**SAN ANTONIO WATER SYSTEM
CENTRAL WATER INTEGRATION PIPELINE
MALTSBERGER TANK REHABILITATION PROJECT
SAWS Job No. 18-8611
SAWS Solicitation No. CO-00183**

**ADDENDUM No. 2
July 19, 2018**

C-2101

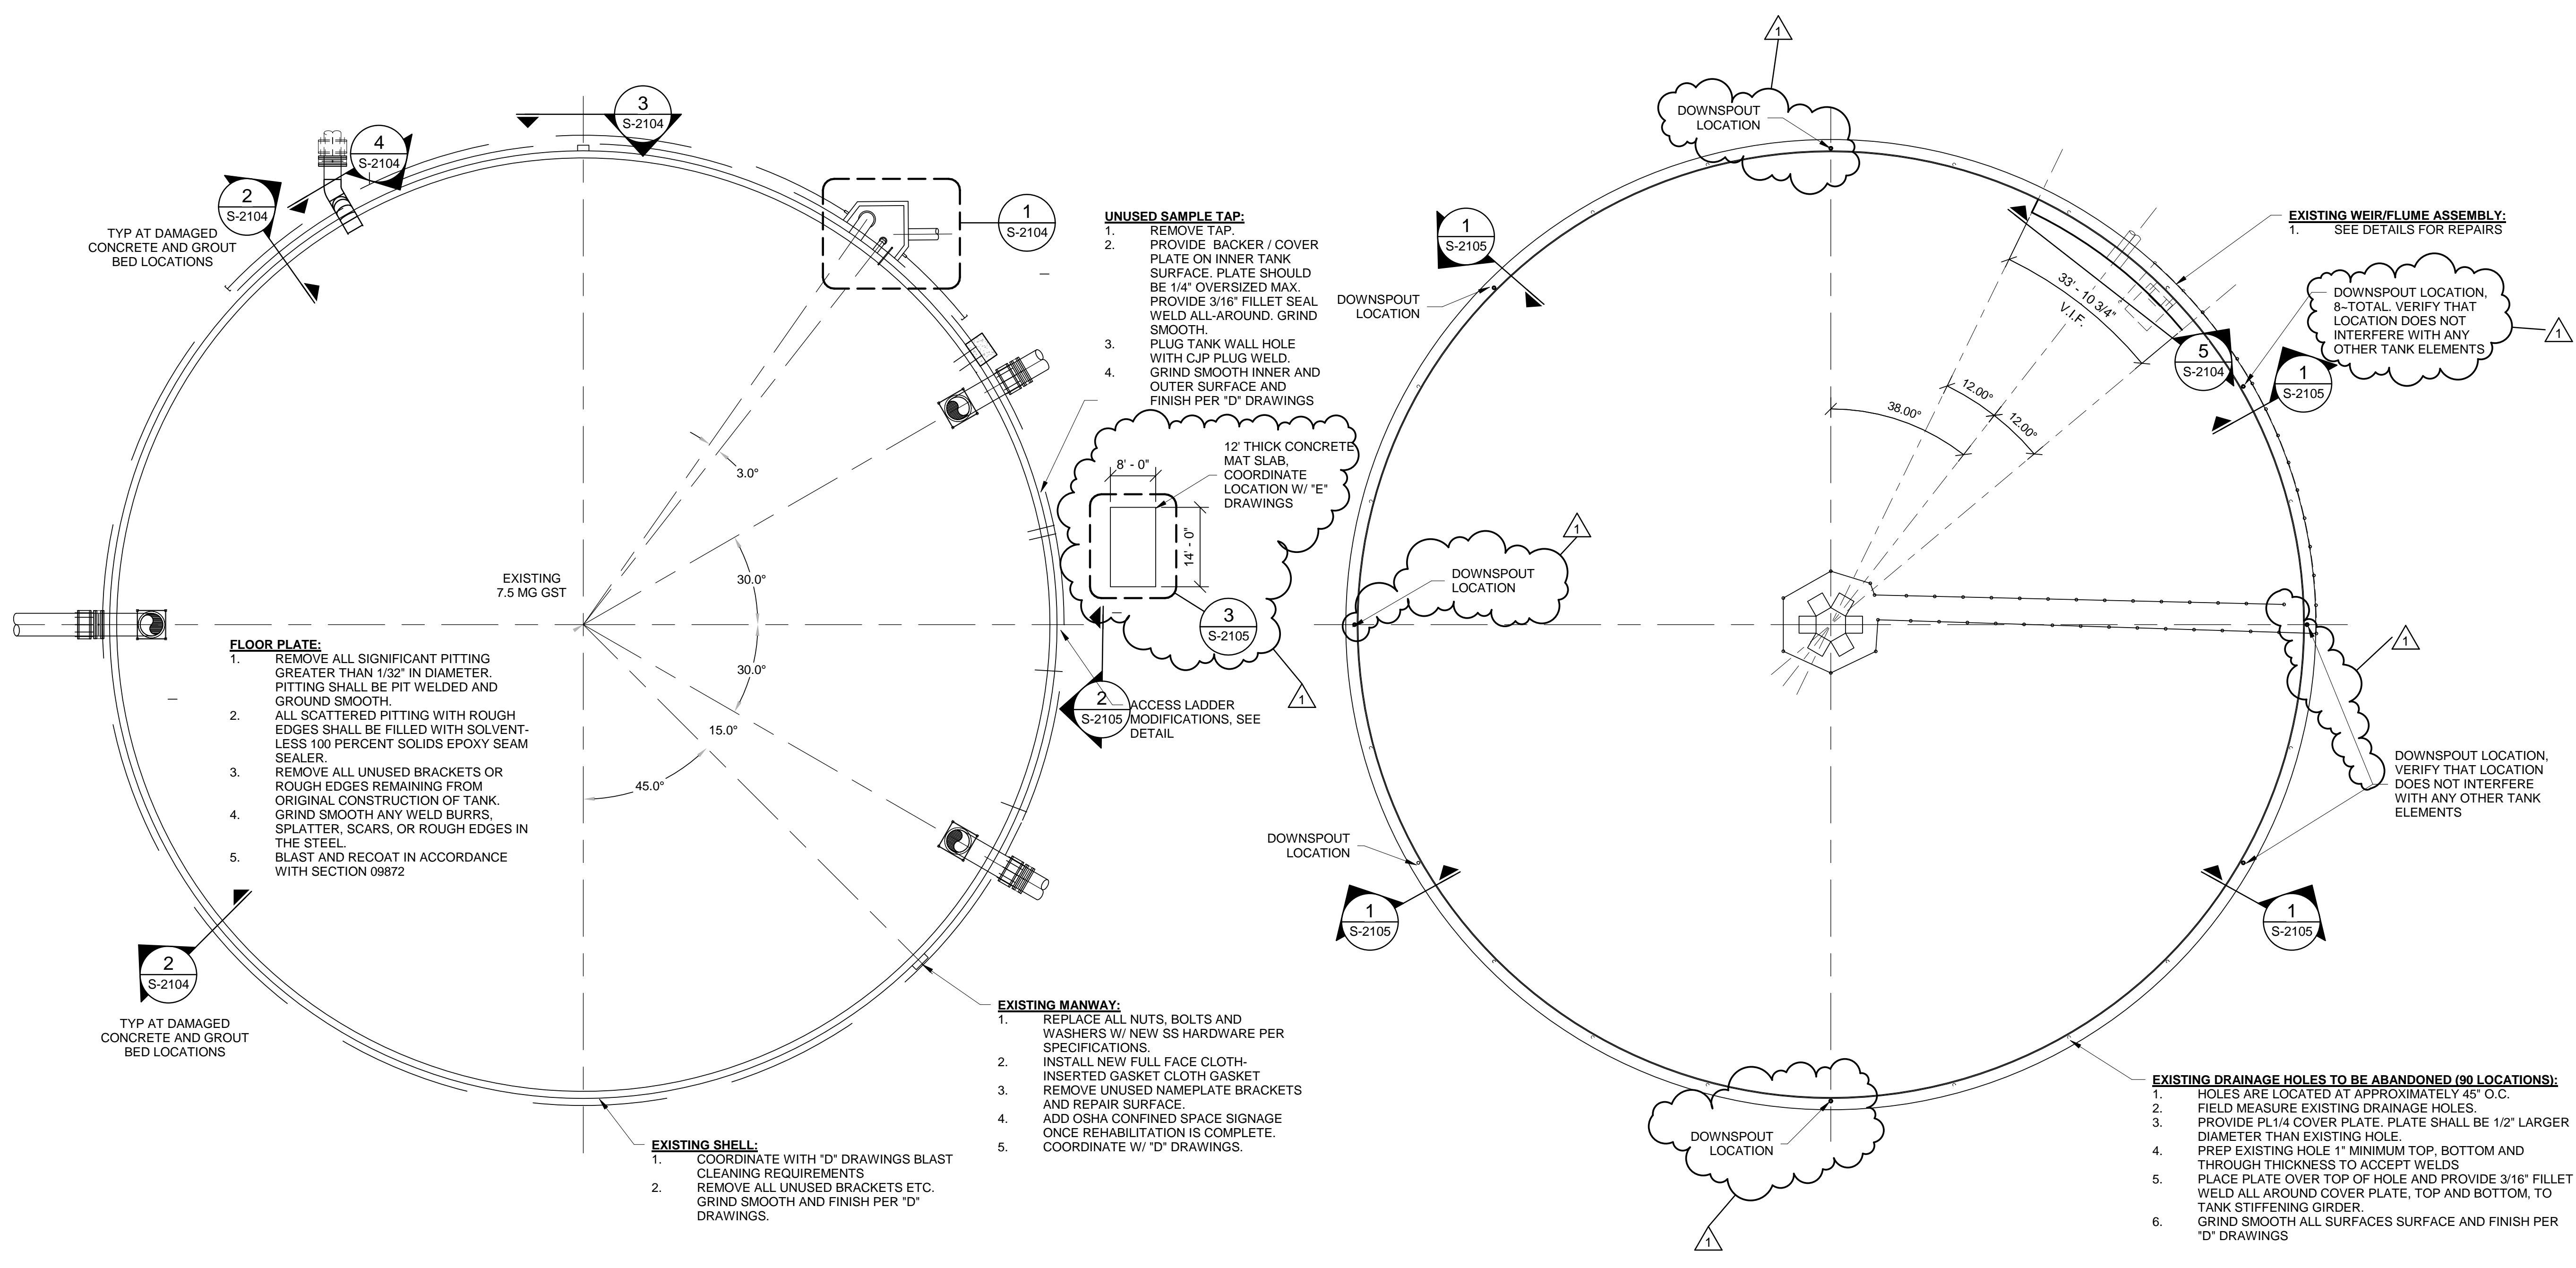
- a) Remove Sheet C-2101 in its entirety and replace with the revised version included in this Addendum. New butterfly valves on the 48-inch outlet pipes have been removed and replaced with temporary plugs.

D-2103

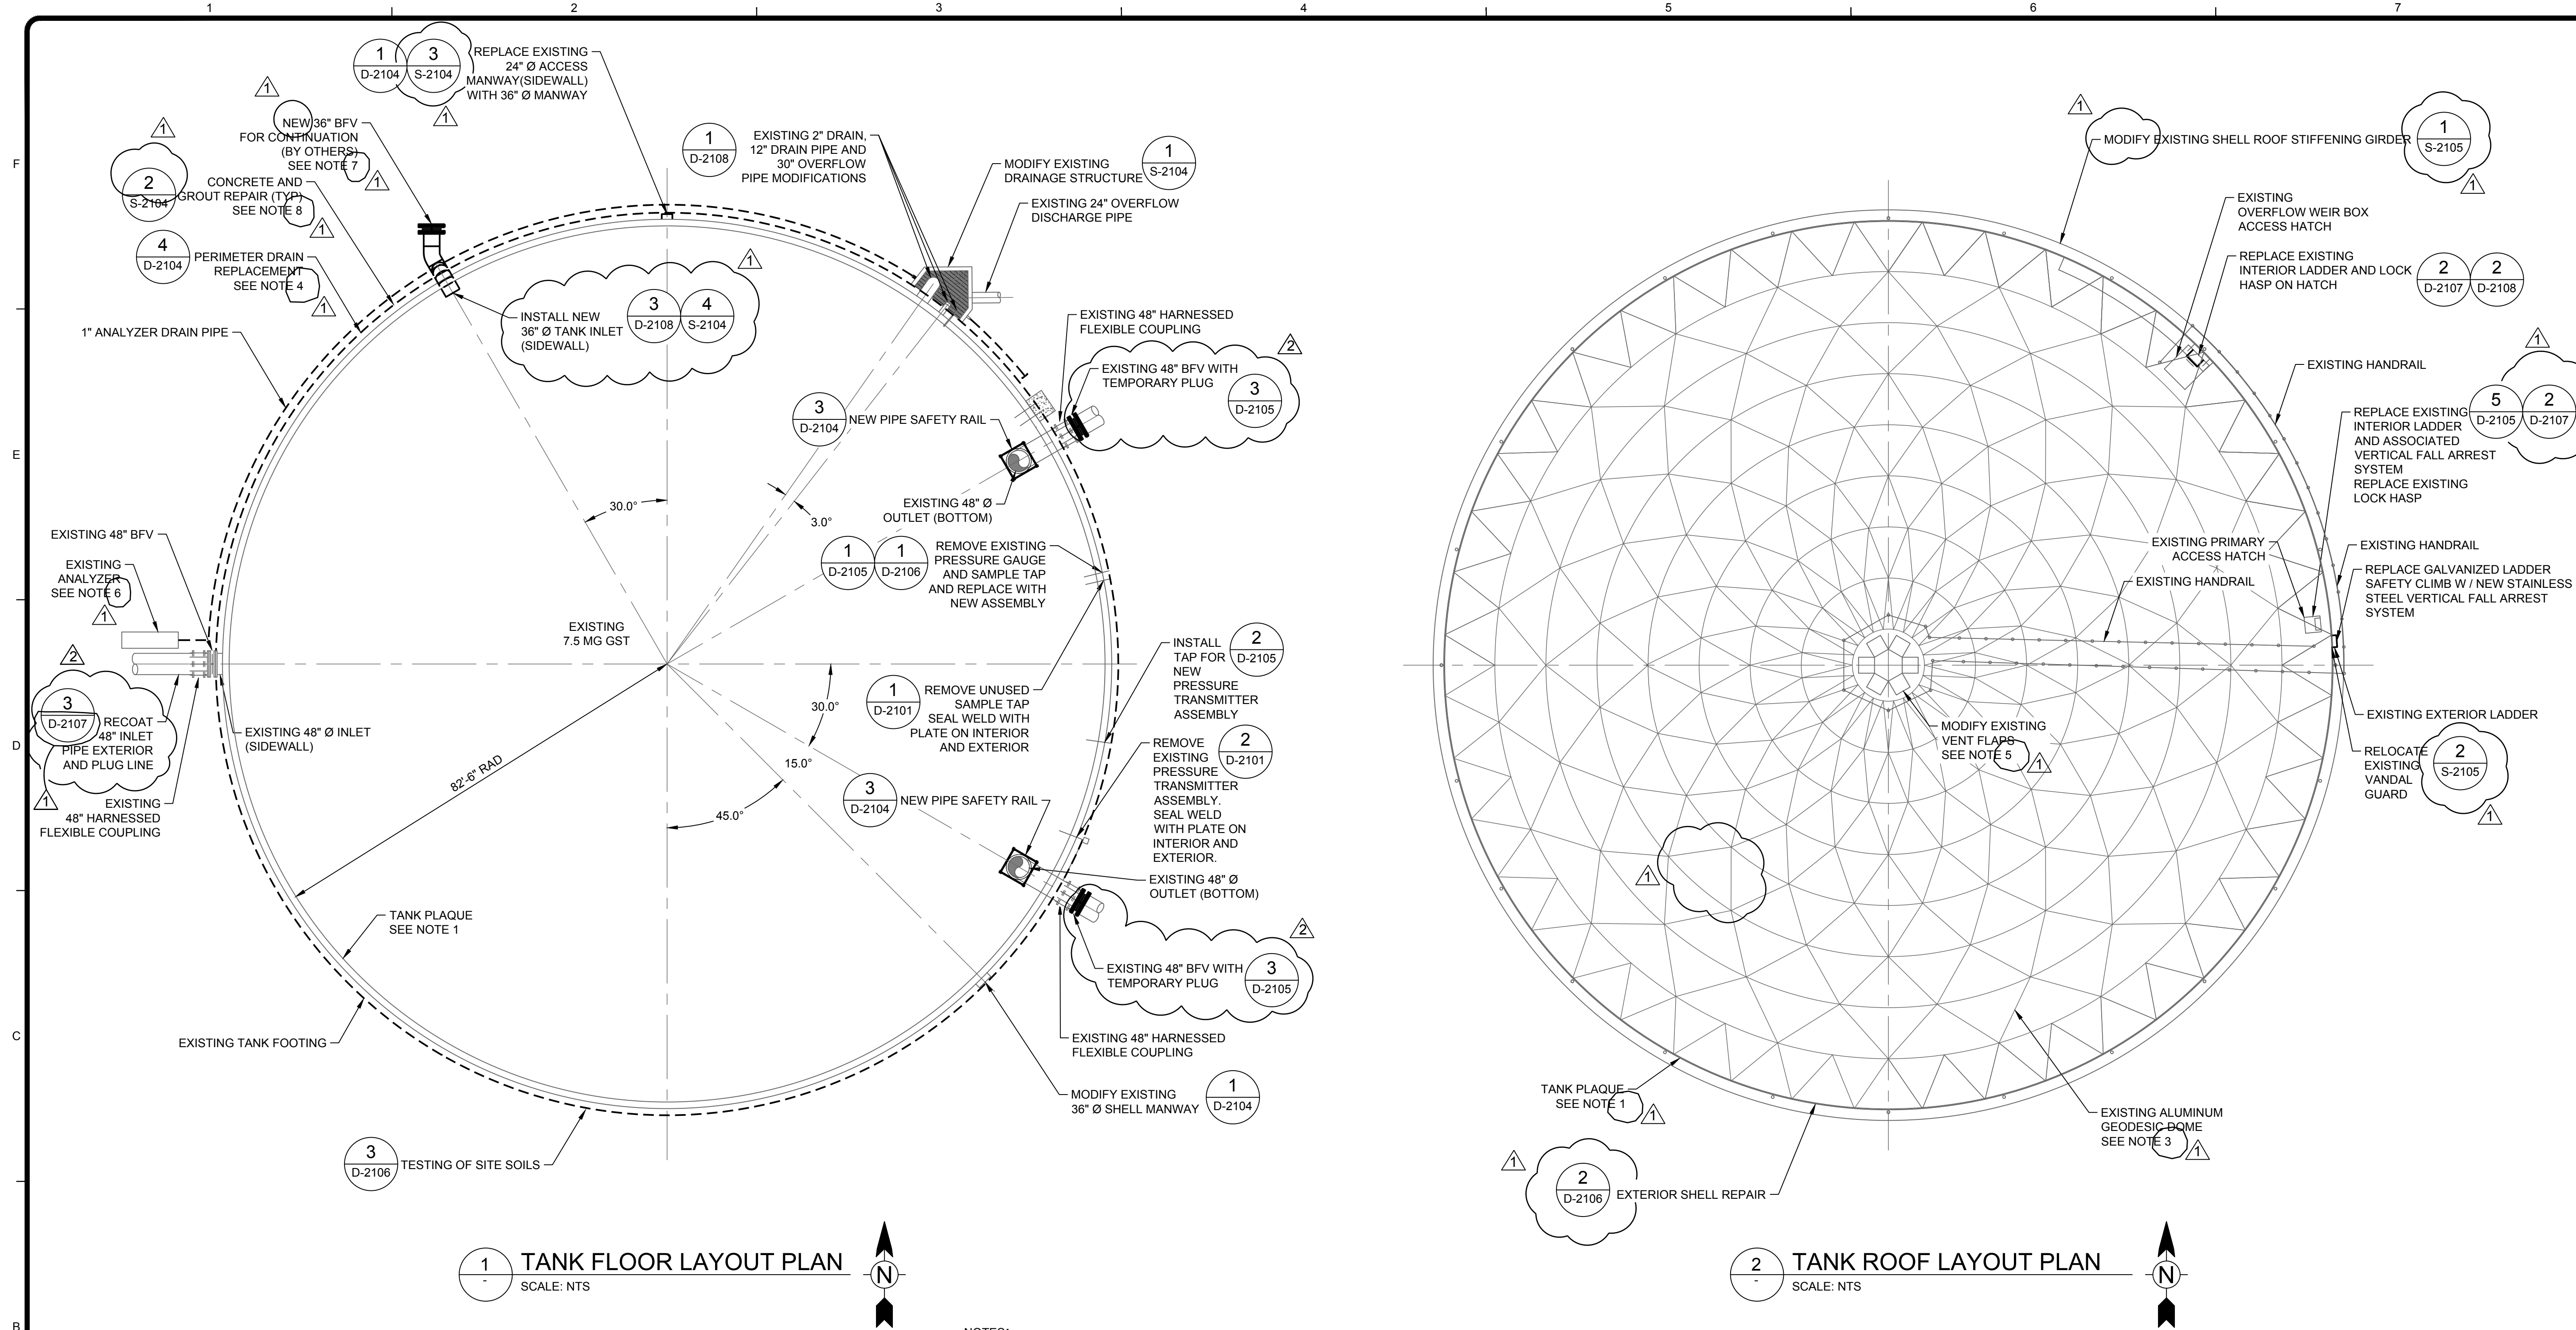
- a) Remove Sheet D-2103 in its entirety and replace with the revised version included in this Addendum. New butterfly valves on the 48-inch outlet pipes have been removed and replaced with temporary plugs.
